MetroWest Engineering, Inc.

RE: Windsor Place, 24 School Street, Wayland MA

I have received your letter to Linda Hansen, Conservation Administrator and the Wayland Conservation Commission, dated June 6, 2018 containing review comments regarding the site plan set for proposed redevelopment of the property located at 24 School Street in Wayland. The Civil Drawings, Hydrologic Analysis and Stormwater Report have been revised to address the comments from your letter. The Site Plans, Sheets One through Five have been revised bearing a revision date of July 5, 2018. The Stormwater Report has been revised and bears a revision date of June, 2018. The Revised Stormwater Report includes; the Hydrologic Analysis, Operation and Maintenance Plan, and supporting calculations documenting compliance with the Mass DEP Stormwater Standards.

Comment Response to Nover-Armstrong Letter dated June 6, 2018
Windsor Place, 24 School Street, Wayland

SHEET 2 OF 5 DATE: SEPTEMBER 6, 2017

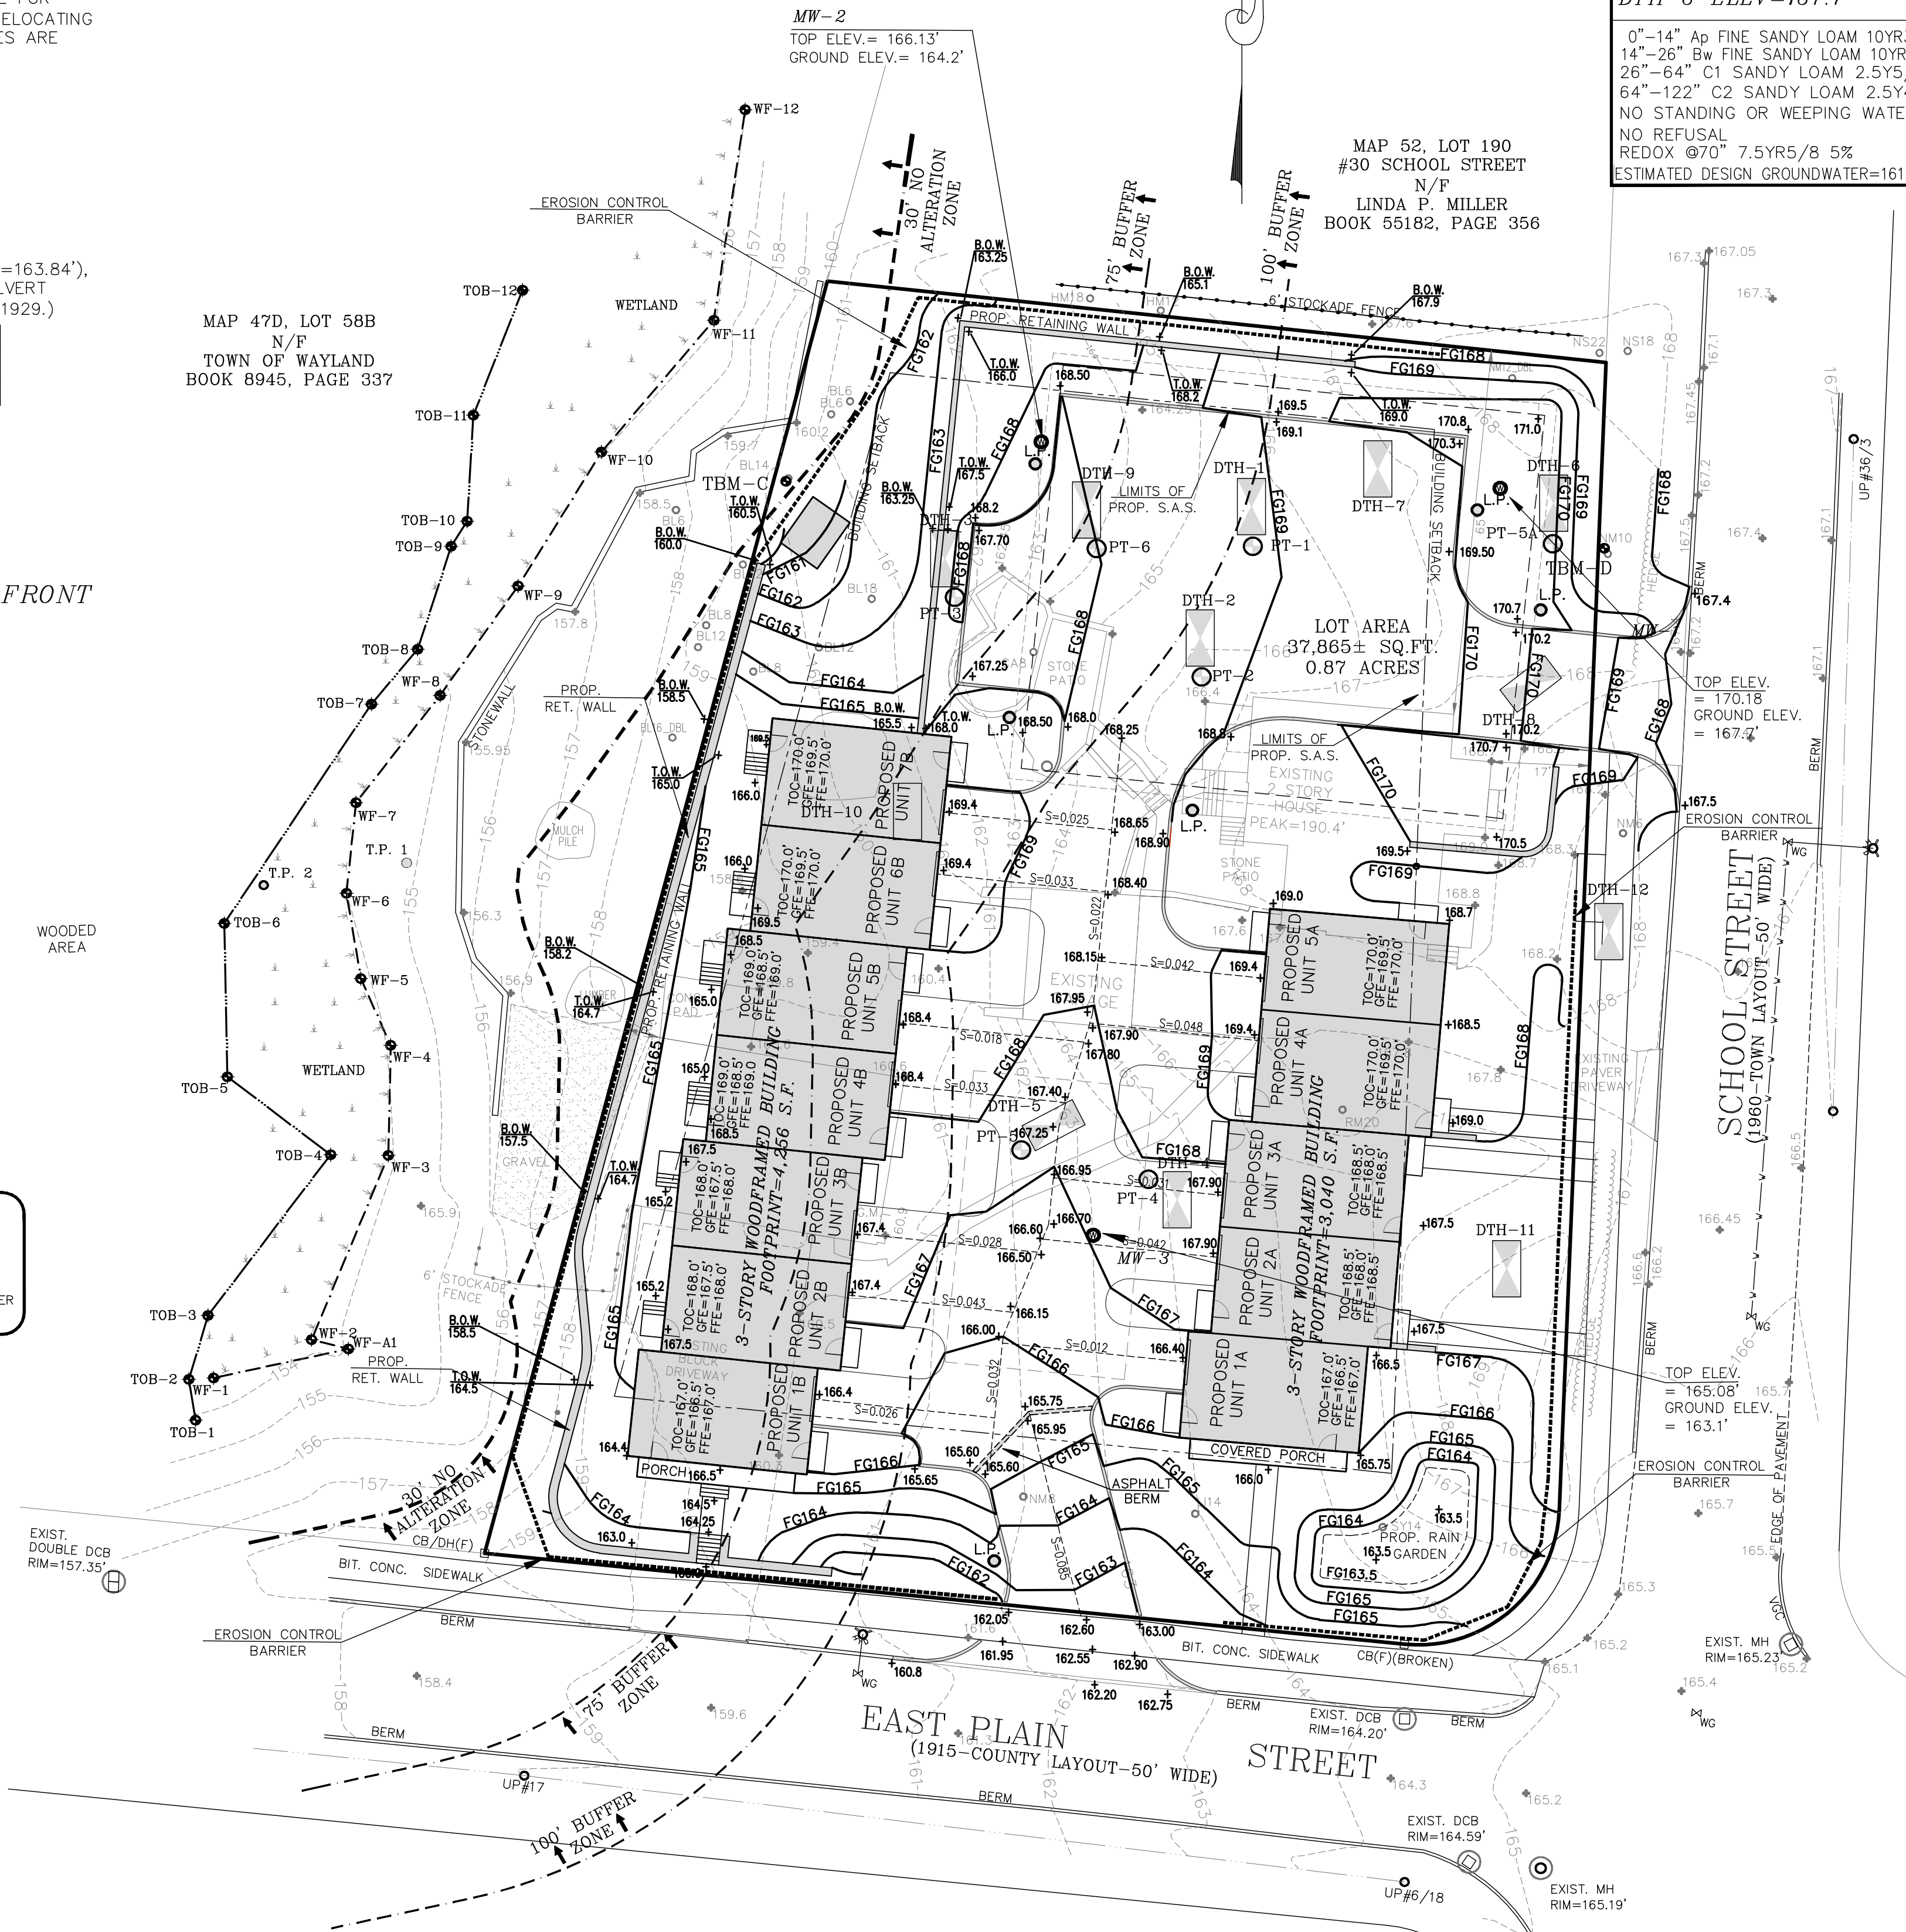
The limits of the bottom of the Rain Garden (elevation 103.5) should be shown on the plans.

A berm has been added to the top of the access drive to East Plain Street to direct runoff to proposed double catch basin 3 (D.D.C.B.3). This is shown on the proposed grading plan, Sheet 2 of 5.

The limits of the rain garden bottom have been added to the plans and shown on the *Proposed Grading Plan*, Sheet 2 of 5.

SHEET 3 OF 5

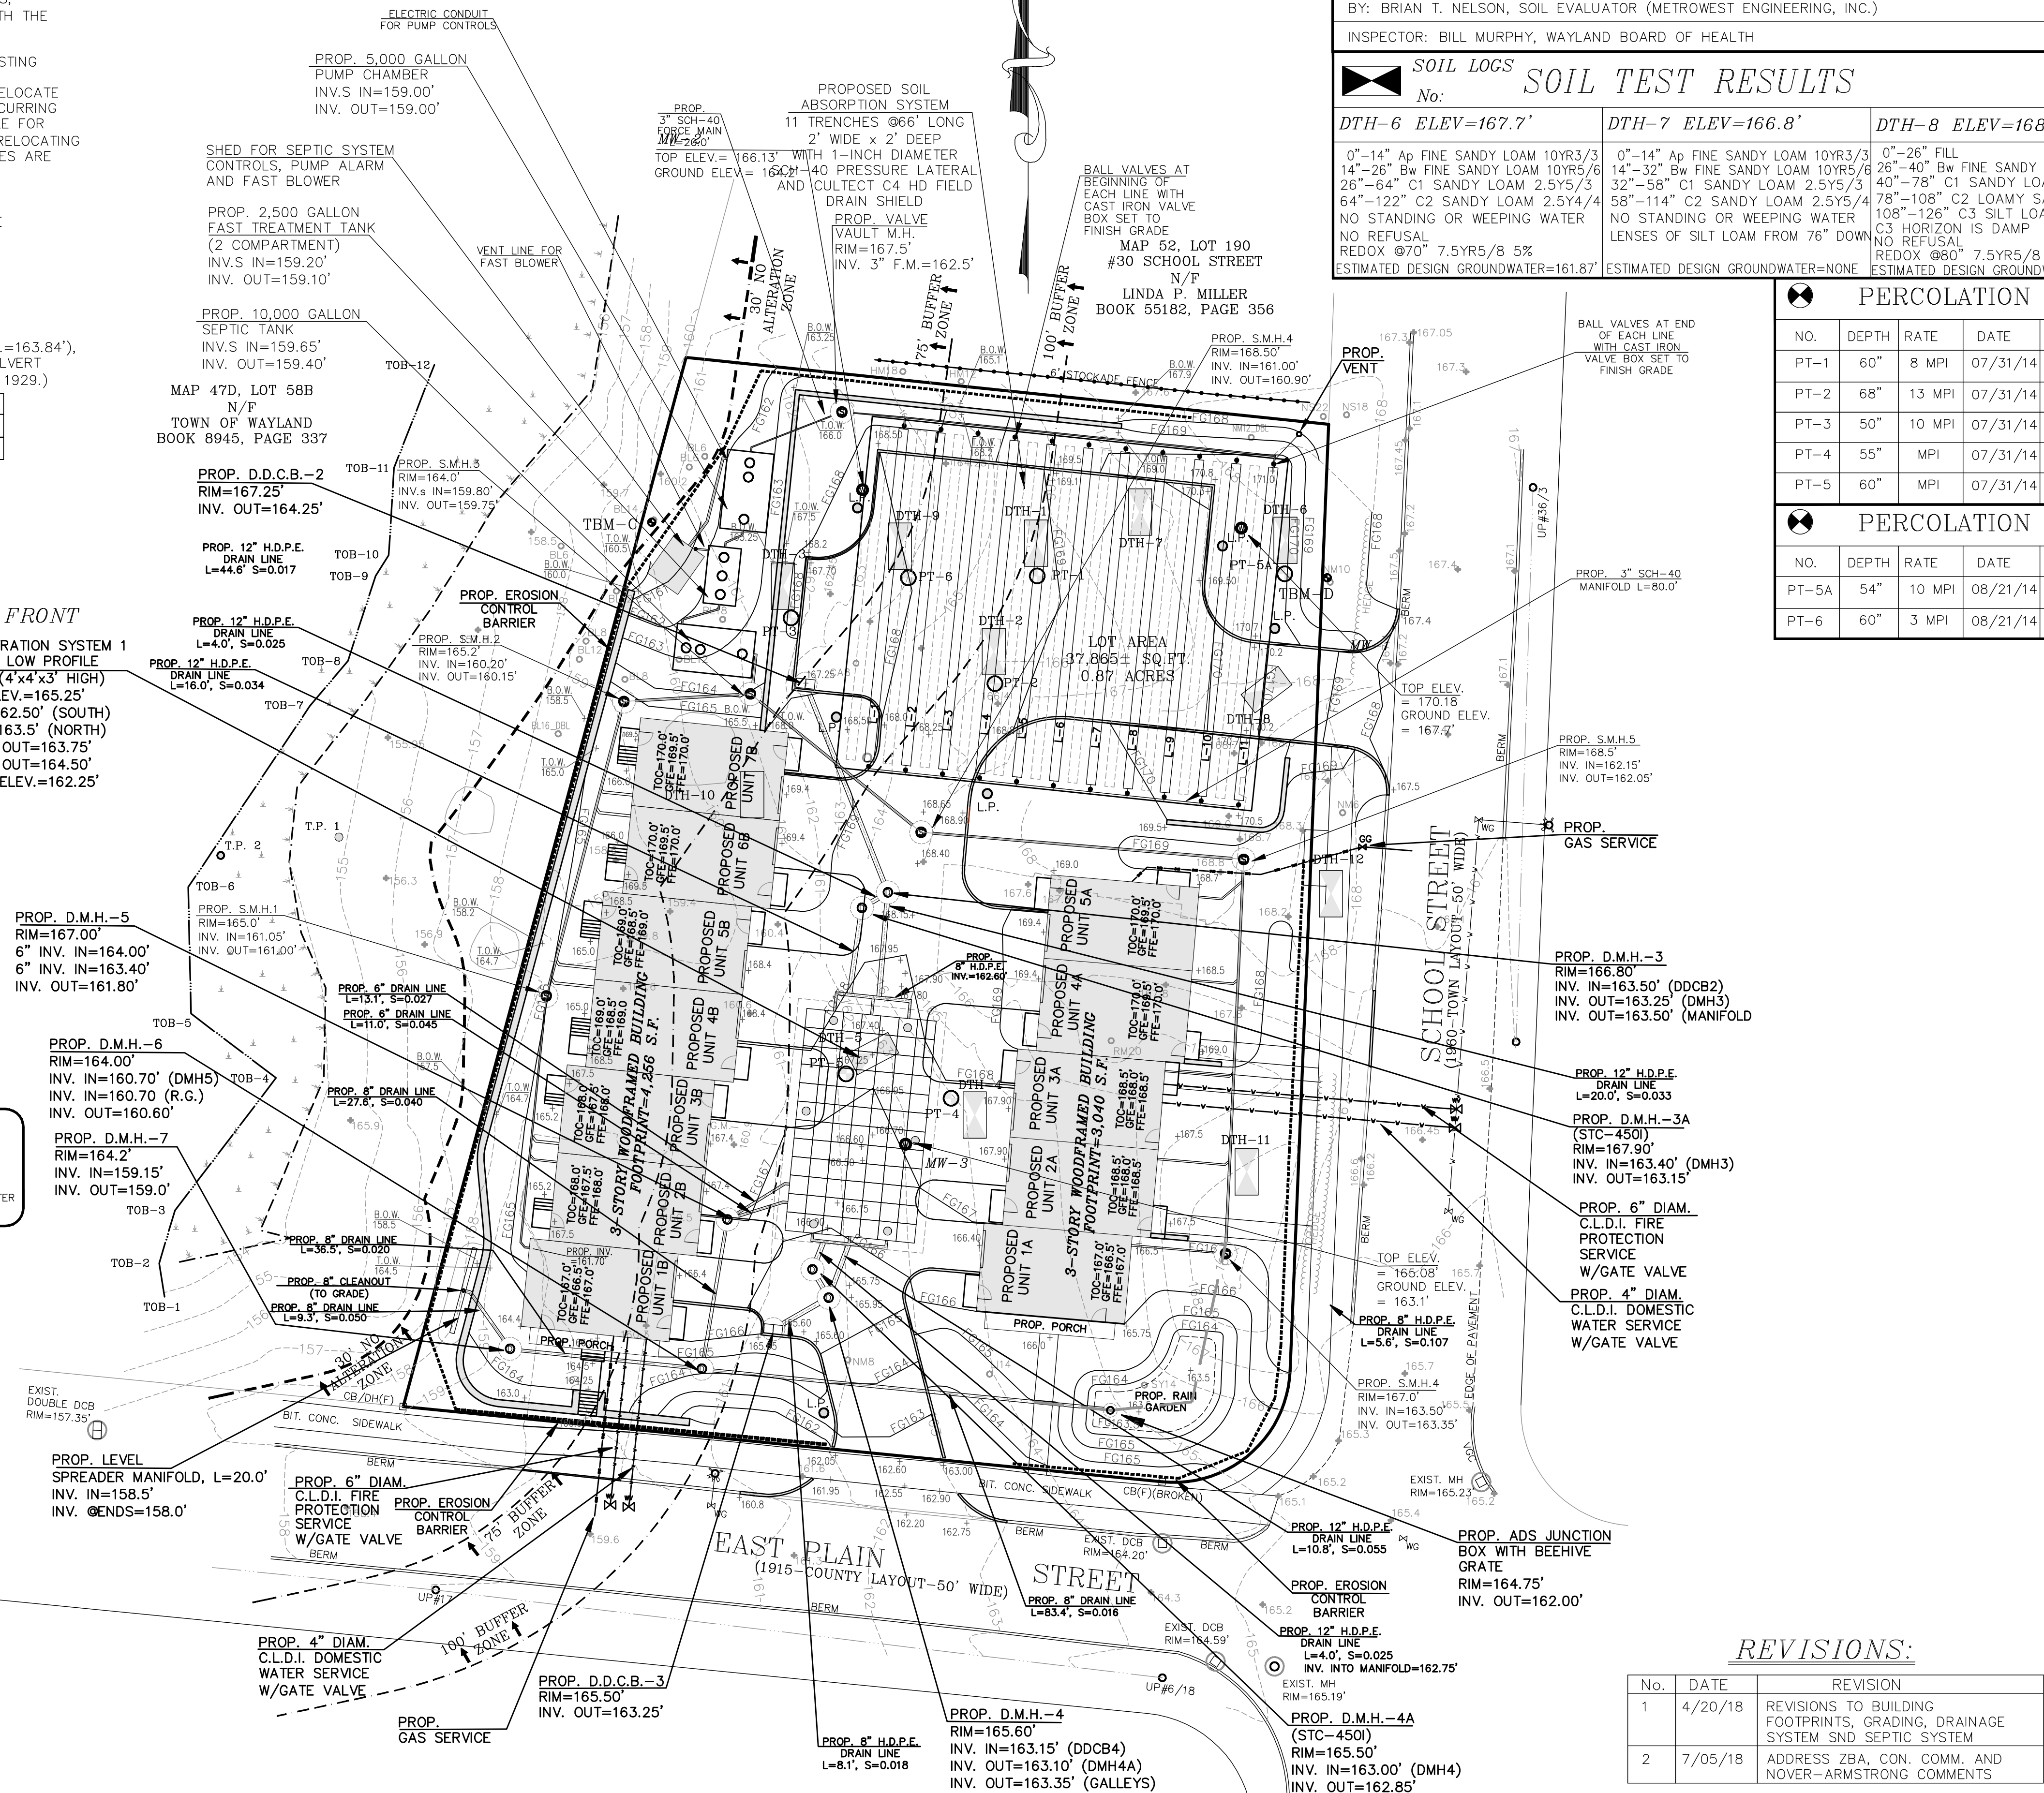
The two 6" diameter outlets from the infiltration BMP are labelled as 8" diameter on the plans and should be corrected.

The outlet pipes for the subsurface infiltration system have been labeled as 6-inch diameter on the *Proposed Site Plan* and *Proposed Details Plan*, Sheets 3 and 4 of 5.

The location of the drain line running from D.D.C.B.-2 AND D.M.H.-3 has been relocated to a location outside the S.A.S. expansion trench. This is shown on the *Proposed Site Plan*, Sheet 3 of 5.
